Case File / Name: SP-62-10 / Bank of North Carolina

Nature of Case: Requested approval of change of use from an office building with no drive thru or

OFFICIAL ACTION: Approval with conditions

SP-62-10 Bank of North Carolina - Site Plan

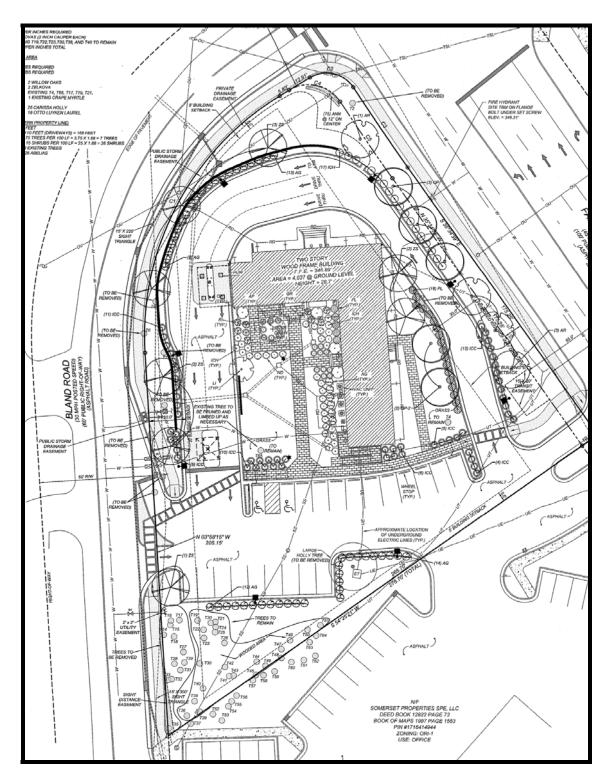
1. To reduce the retaining wall's visual impact, plant trailing, vining plants atop the wall

To improve unity of site development. any retaining walls should be of brick matching that of the building and the proposed ground mounted sign.

The landscape plan included with the sets provided to the Planning Commission has already been revised to show Carolina Jasmine along the retaining wall.

The bank has agreed to construct the retaining walls out of brick to match the building and ground-mounted sign.
